UNITED STATES PATENT AND TRADEMARK OFFICE

| APPLICATION NO. | FILING DATE | FIRST NAMED INVENTOR | ATTORNEY DOCKET NO. | CONFIRMATION NO. |
|--|-------------|----------------------|---------------------|------------------|
| 10/822,572 | 04/12/2004 | Shawn L. Lloyd | ITL.1113US (P18785) | 2638 |

| Office Action Summary | Application No. 10/822,572 | Applicant(s) LLOYD ET AL. | |

- 1) ☒ Responsive to communication(s) filed on 5-5-06.
- 2a) ☒ This action is **FINAL**. 2b) ☐ This action is non-final.
- 3) ☐ Since this application is in condition for allowance except for formal matters, prosecution as to the merits is closed in accordance with the practice under *Ex parte Quayle*, 1935 C.D. 11, 453 O.G. 213.

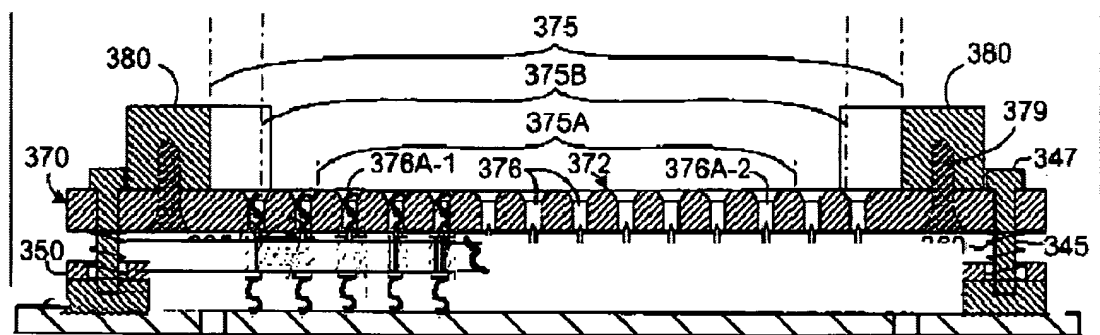
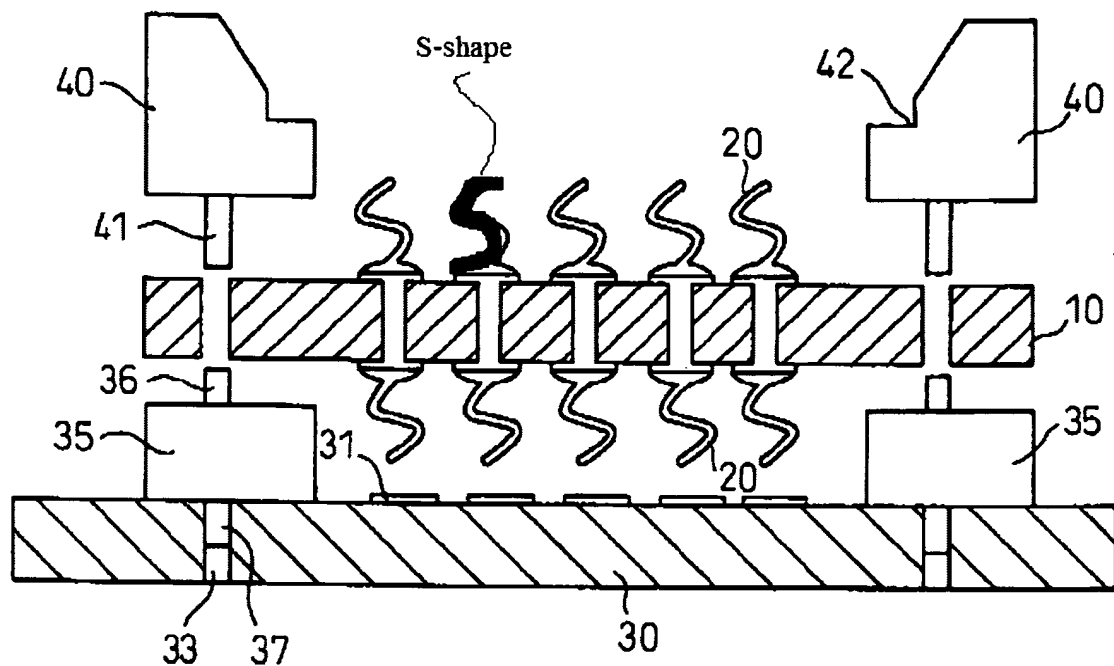
Higashi shows spring contacts 20 (see examiner's figure) are S-shaped and the combination of Hornchek and Higashi is considered to be adapted to make wiping electrical contact with a solder ball inserted into the aperture (see examiner's figure).

Further, it would have been obvious to one of ordinary skill in the art at the time the invention was made to replace the mounting plate 350 with spring contacts 320 of Hornchek with the mounting plate 10 with the S-shaped spring contact 20 Higashi (see examiner's figure).

Higashi shows spring contacts 20 (see examiner's figure) are S-shaped and the combination of Hornchek and Higashi is considered to be adapted to make wiping electrical contact with a solder ball inserted into the aperture (see examiner's figure).

Further, it would have been obvious to one of ordinary skill in the art at the time the invention was made to replace the mounting plate 350 with spring contacts 320 of Hornchek with the mounting plate 10 with the S-shaped spring contact 20 Higashi (see examiner's figure).

Fig.10

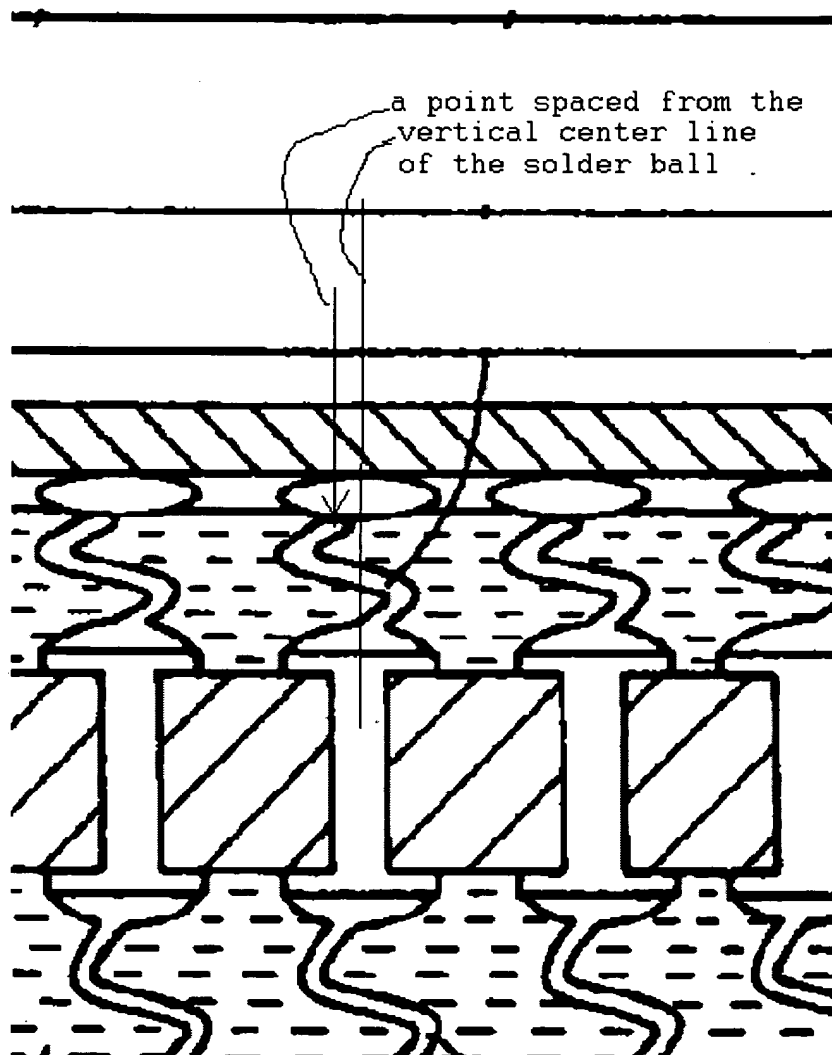
■ In response to applicant's response (page 5, line 16 of applicant's remarks dated 1-26-06) that the wiping electrical contact with the solder ball is at a pint spaced from the vertical center line of the solder ball has been explained explicitly, the examiner disagrees. The examiner disagrees because a review of applicant disclosure (also see US Publication 20050227509 of applicant's disclosure) does not show any special definition requiring a narrowing of the meaning of wiping nor is the text seen to mention the centerline of the solder ball. Further, applicant's figure 1 shows a contact adjacent the solder ball that is not seen to differentiate between the structure of Higashi (figure 10 (see examiner's figure)) that also shows a contact adjacent the solder ball.

■ In response to applicant's assertion (page 5, line 5 of applicant's remarks dated 1-26-06) that it is clear that figure 10 of Higashi hits the solder ball centrally, the examiner disagrees. Further, applicant's figure 1 shows a contact adjacent the solder ball that is

not seen to differentiate between the structure of Higashi (figure 10 (see examiner's figure)) that also shows a contact adjacent the solder ball and both contacts are not centered upon the centerline of the solder ball (see examiner's figure).
